**DEVELOPMENT FACILITATIVE TEAM (DFT)**  
**Code Enforcement Comments**

**PR-2019-002134**

**SI-2024-00716 – SITE PLAN DFT**

**Project Name:** HOPE Christian School. Phased development project. Near Louisiana and Palomas.

**NORTH ELEVATION (FRONTAGE ON PALOMAS AVE NE)**

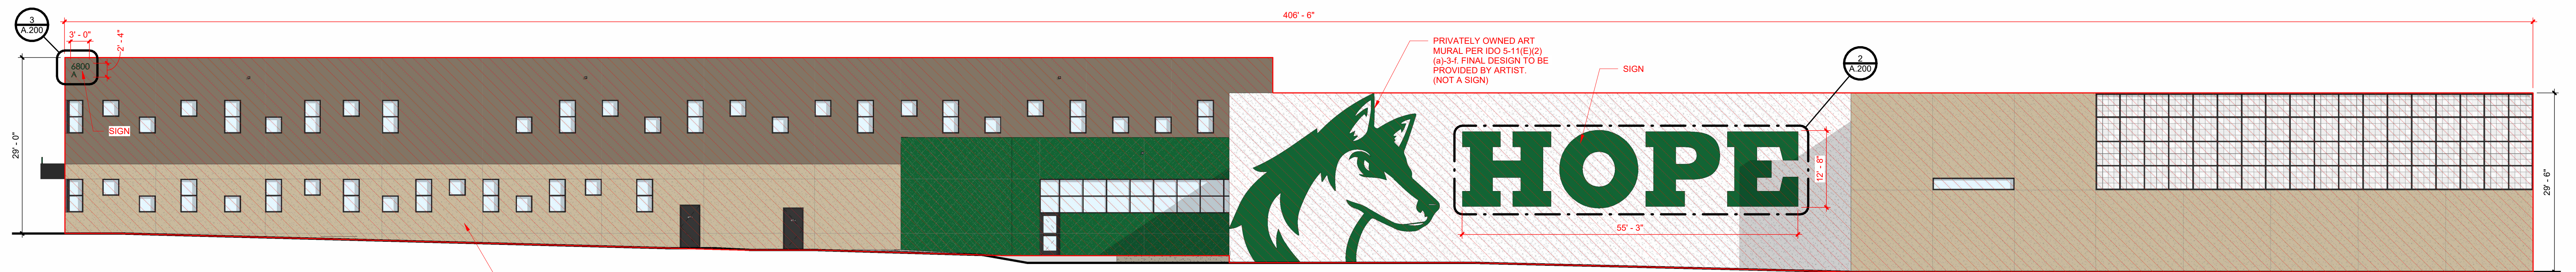
6. Signage must meet all requirements as per IDO 5-12, Table 5-12-2. Painted wall graphic with name of school would be considered a sign, and would have to be limited in size to 10% of the façade area of the wall, or a Variance obtained for the difference. Clarify calculations for area of façade being used.

**6. Please see below attached SIGN AREA DIAGRAM** clarifying sign area calculation for facade facing Palomas Ave NE and compliance per IDO 5-12, Table 5-12-2.

TOTAL AREA OF FACADE = 12,232 SQUARE FEET  
 TOTAL SIGN AREA = 707 SQUARE FEET  
 707 / 12,232 = 6% OF TOTAL FACADE AREA  
 (10% ALLOWED PER IDO)

**1 SITE PLAN**  
1" = 30'-0"

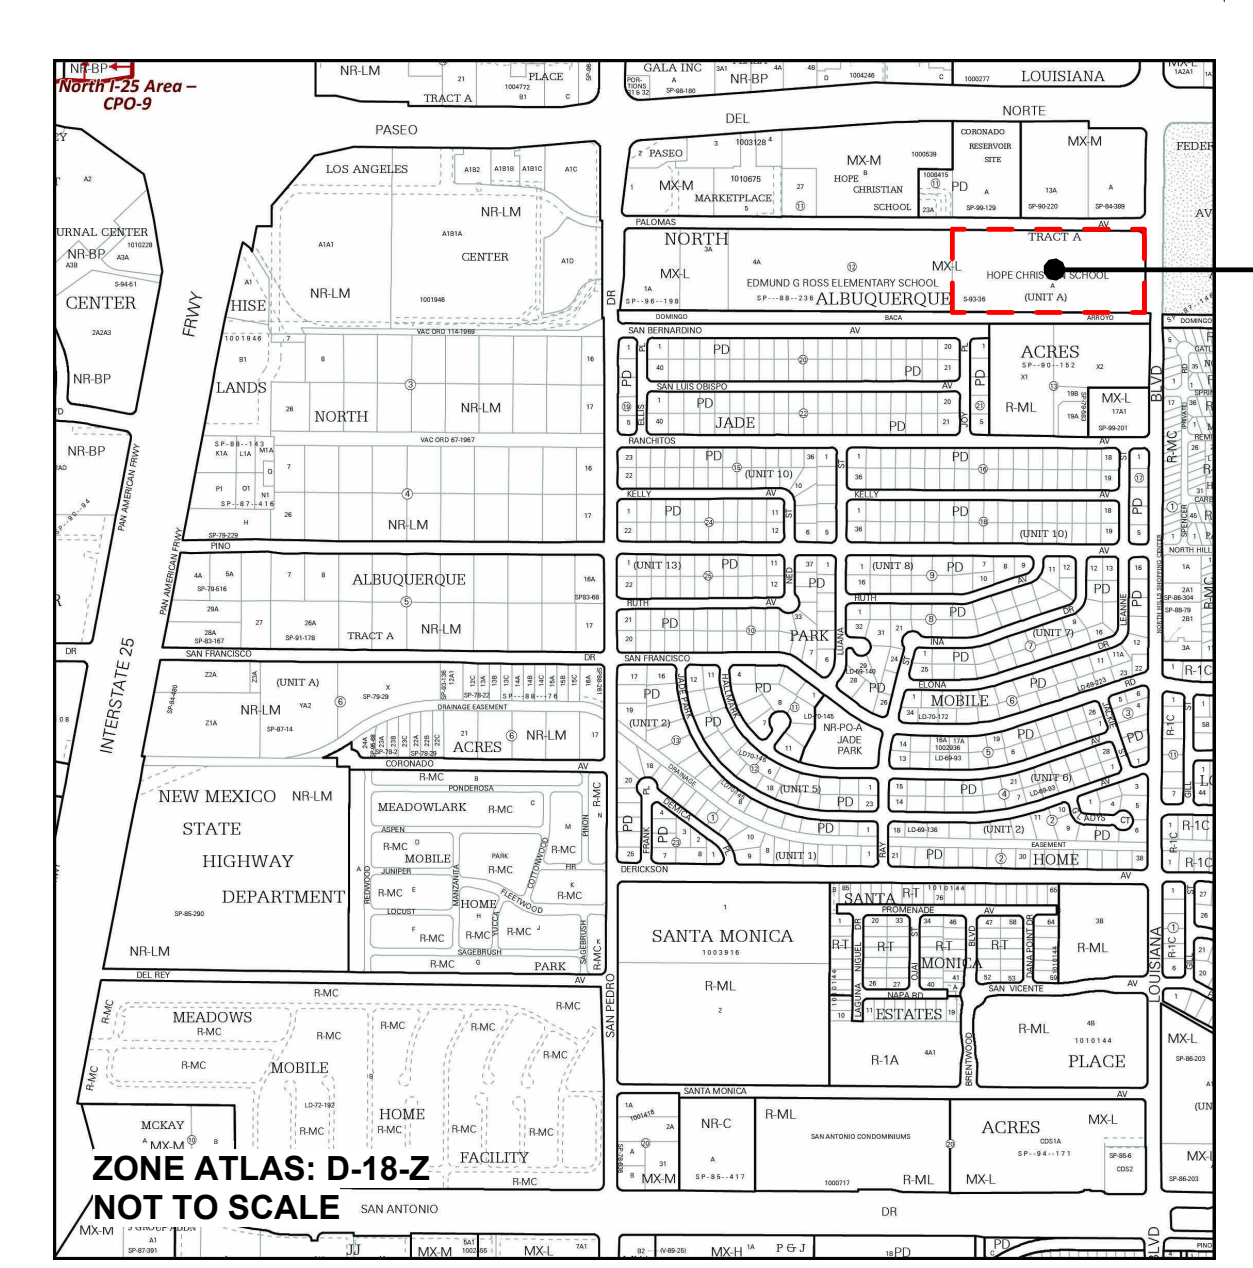
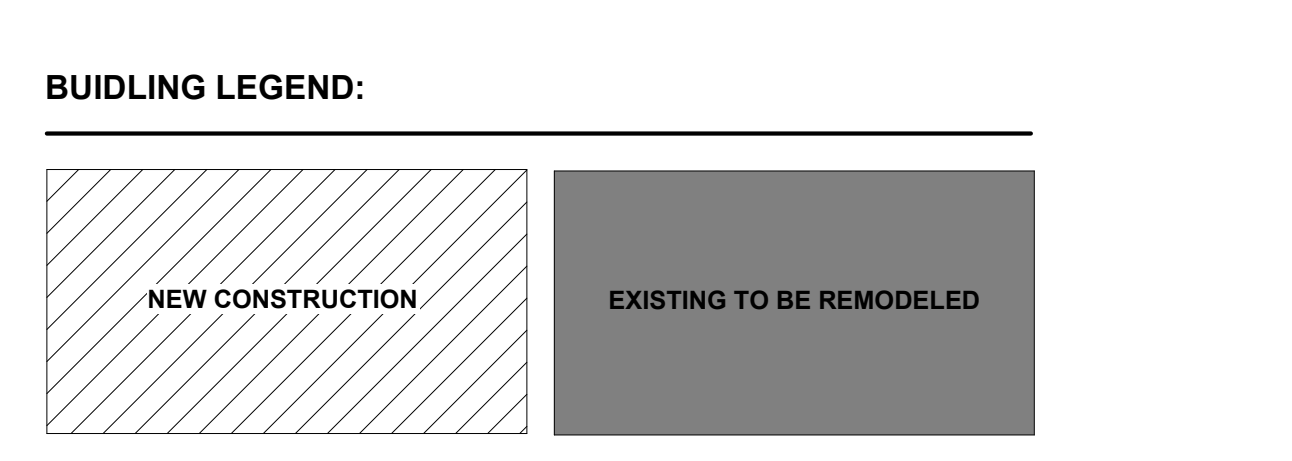
1. Property is zoned MX-L and must meet all dimensional standards of IDO T5-1(D), Table 5-1-2.
2. Parking requirements – see Table 5-5-1, and show calculations for requirements and parking provided on site plan. Proposed plans for each phase must meet all applicable parking requirements for all actual uses/activities for the lot through at that time period.

- Clarify and confirm that all development, landscaping, and screening are within private property areas and they do not encroach into the public right of way. Exception can be made for the landscape buffer along the sidewalk.

- The project & application numbers must be added to the Site Plan and any associated IL.

2. To the best of our knowledge, the proposed development meets all parking requirements in Table 5-5-1. See calculation on Site Plan (AS.100).

**APPLICANT RESPONSE:** ALL DEVELOPMENT, LANDSCAPING (OTHER THAN BUFFER ALONG SIDEWALK), AND SCREENING ARE WITHIN THE BOUNDARIES OF PRIVATE PROPERTY. SEE REVISED SITE PLAN (AS.100) ATTACHED BELOW.

PROJECT NUMBER, APPLICATION NUMBER, AND IL HAVE BEEN ADDED TO REVISED SITE PLAN (AS.100) ATTACHED BELOW.

**ATTACHMENT:**  
**01/26/24 SITE PLAN WITH**  
**SOLID WASTE SIGNATURE\***

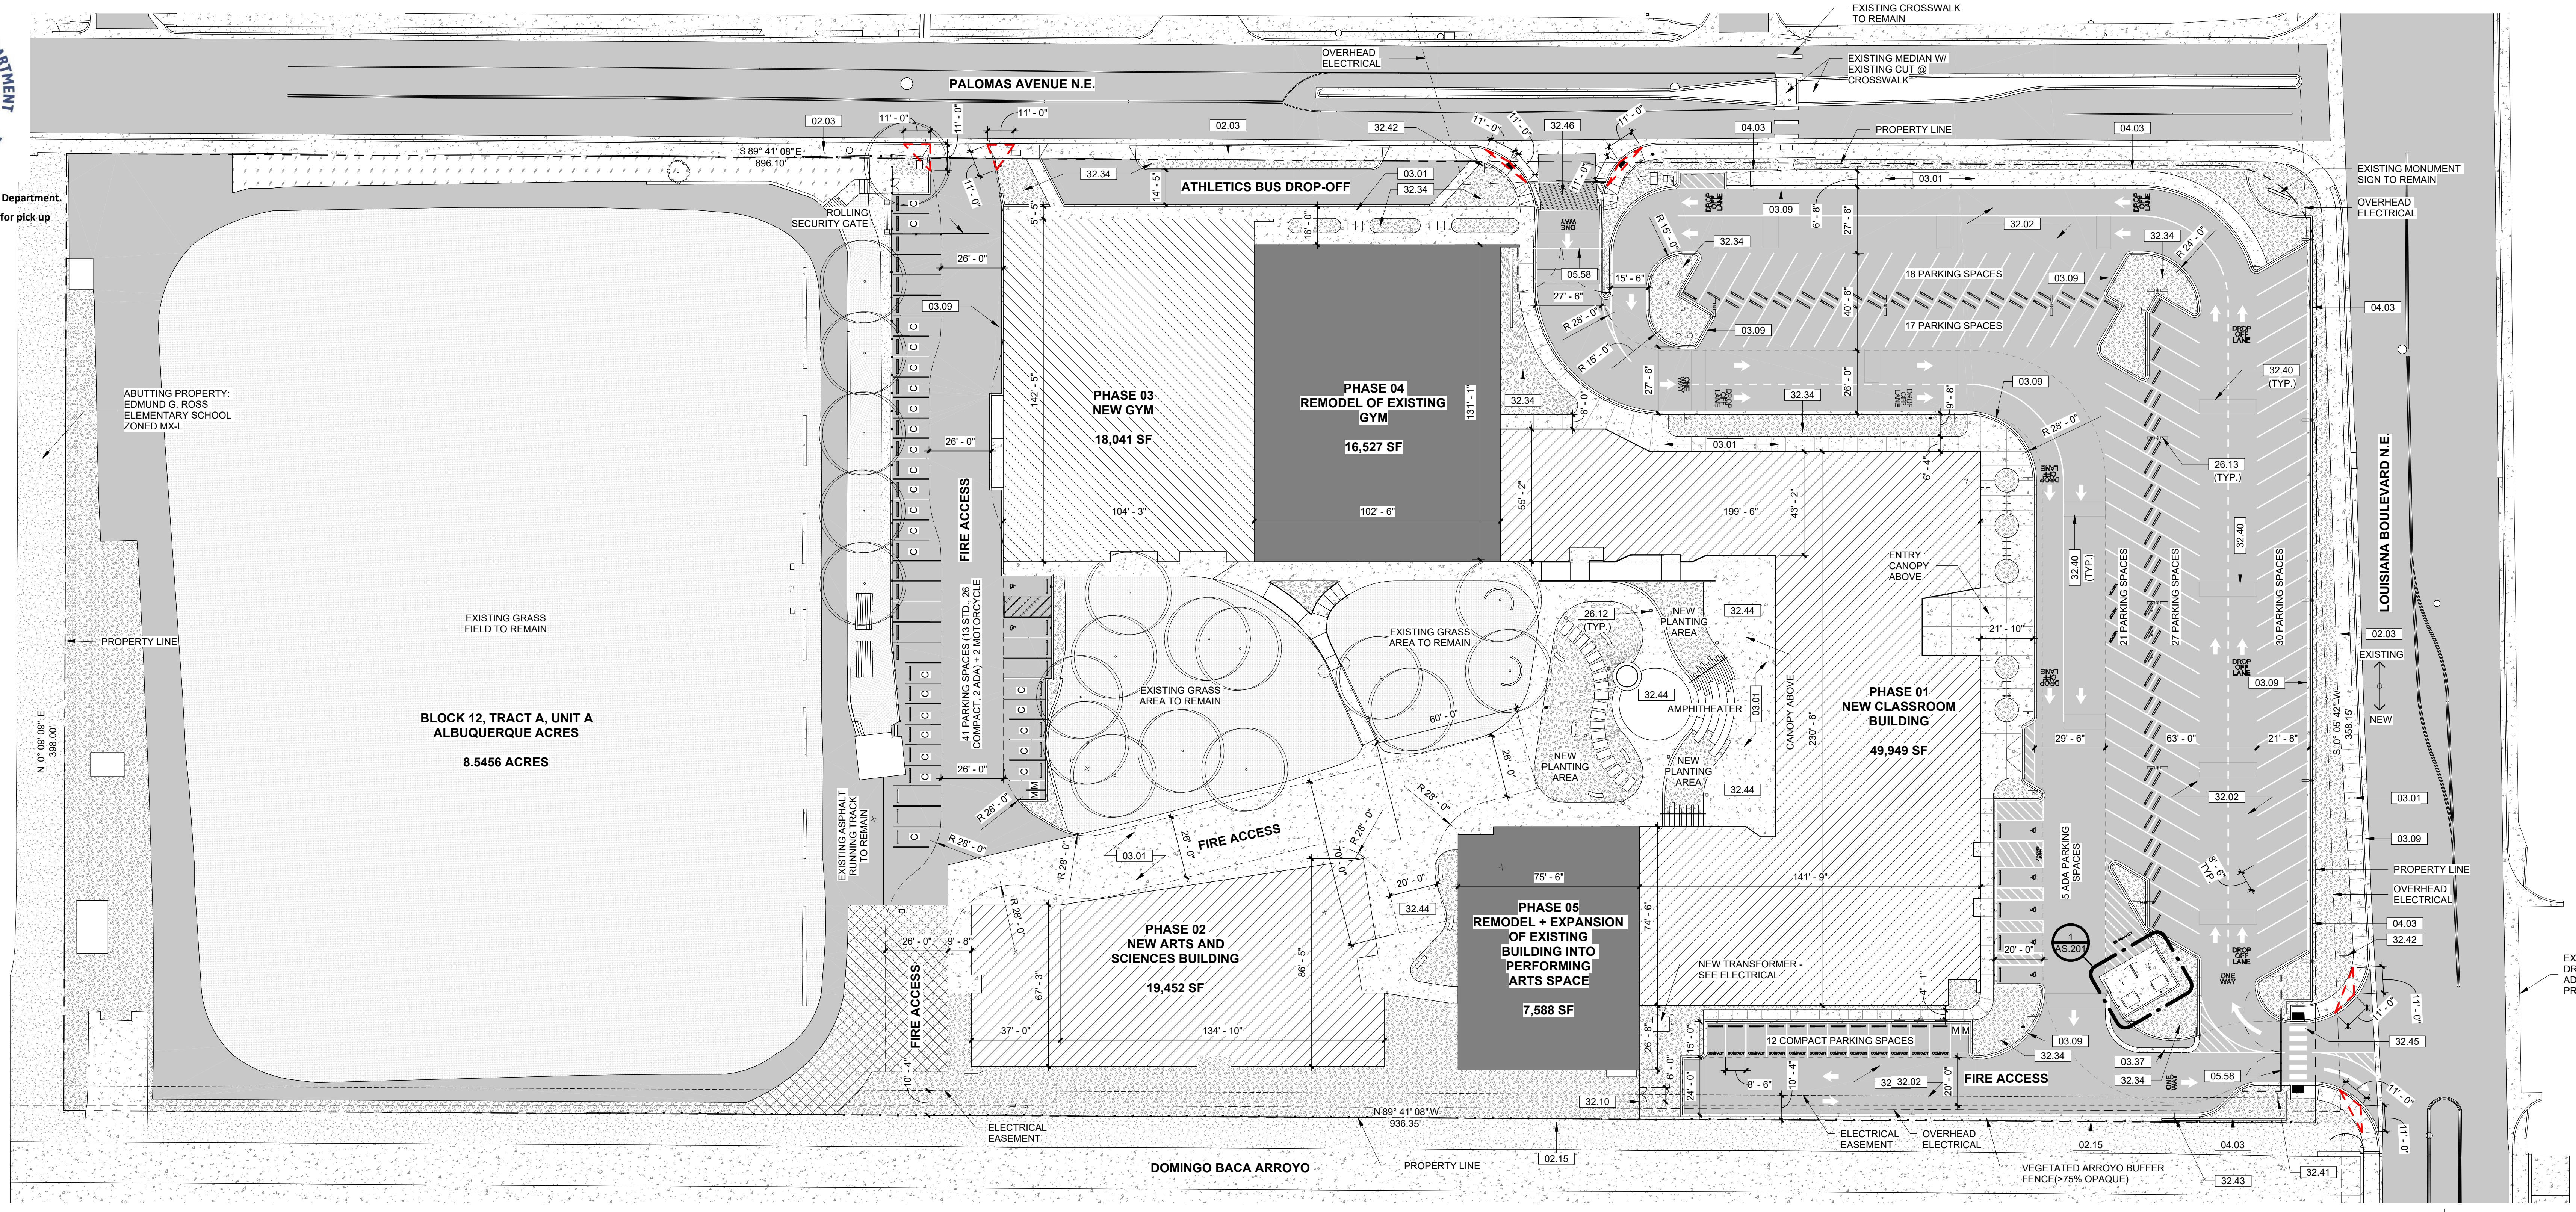
has approved the Fire 1 plan. \*Clarify if Solid Waste has also reviewed and approved the

site plan. **APPLICANT RESPONSE:** SOLID WASTE SIGNED THE SITE PLAN ON 01/26/24 (SIGNED COPY ATTACHED BELOW). PLAN HAS SINCE BEEN REPLOTTED, BUT NO CHANGES AFFECTING SOLID WASTE HAVE BEEN MADE SINCE THEY GAVE THEIR APPROVAL.
